# 119 Warren Road, PARKDALE

Planning Permit Application

Planning Permit No: PA2503524

Officer Assessment Report  
Development Assessment

*Figure 6: Aerial view of existing trees on site proposed to be removed*

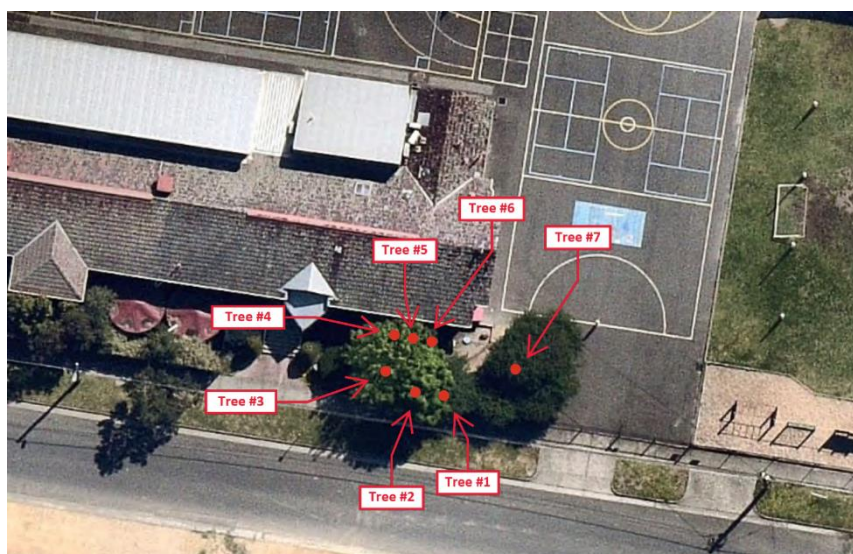
24. The council provided a 'no objection' response subject to a number of recommended conditions on 11 March 2025. The council's primary concerns relate to the proposed vegetation removal to facilitate the proposed works, and protection of trees during construction. Specifically, the council does not support the removal of Tree 7 (*Diospyros hasseltii*) for the following reasons:

- *The tree is protected under Local Law. \*refer to section 25 for further information*
- *The tree has been assessed to be of high retention value, due to its age, size, health, shade, habitat, low risk of failure.*
- *The tree protection zone (TPZ) is located outside of the proposed building footprint and therefore, the tree will not suffer intrusion into the tree protection zone. However, tree protection fencing should be installed prior to demolition and retained throughout works to protect the tree from incidental construction impacts ensuring the viability of the tree post completion of works.*
- *The proposed works around Tree 7 and suggested protection methods should form part of a tree management plan, in line with AS4970-2009 Protection of Trees on Development Sites.*

- *Tree number #7 referred to in the City of Kingston referral response dated 1st March 2025 Tree is unable to be retained due to the difference in existing and proposed levels. Given that the tree canopy of tree #7 is quite low, if the tree were to be retained, only canopy would be above the forecourt level. This would result in unusable space around the tree canopy at forecourt level and the tree would be unlikely to survive. Hence, the proposal to remove the tree and plant a new more suitable tree.*

43. DTP considers the removal of the Tree 7 appropriate within the context of the proposal for the following reasons:
  - The submitted arborist report identifies Tree 7 as an exotic species of medium retention value.
  - Though the tree is relatively healthy, the canopy height of the tree is low (approximately 2m). If the tree were to be retained, only the canopy would sit above the proposed forecourt level. The canopy spread sitting at forecourt level would impact the amount of usable entry space and the arborist report assesses that the tree would be unlikely to survive over time.
  - Additionally, reconfiguration to accommodate the existing tree would require the forecourt to have a void space (approximately 1m deep) around the tree's multi-stemmed trunk that could otherwise cause safety concerns for staff, students and visitors.

- A replacement tree is proposed to suitably replace Tree 7 whereby the raised tree canopy will enable useable space within the forecourt, as well as have soil depths commensurate with the new finished level within the forecourt.

44. DTP supports a number of the recommended conditions put forward by the council in relation to tree protection measures and landscaping. Conditions requesting the retention of Tree 7 are not considered suitable within the scope of the proposal. However, the council's recommended condition for any new planted tree to be a minimum of 2m in height will be adopted into the permit.
45. In addition, conditions requesting for the planting of 80% indigenous medium to large canopy tree species will be adopted into the permit. DTP consider the planting of a medium to large indigenous tree to replace Tree 7 an appropriate outcome.
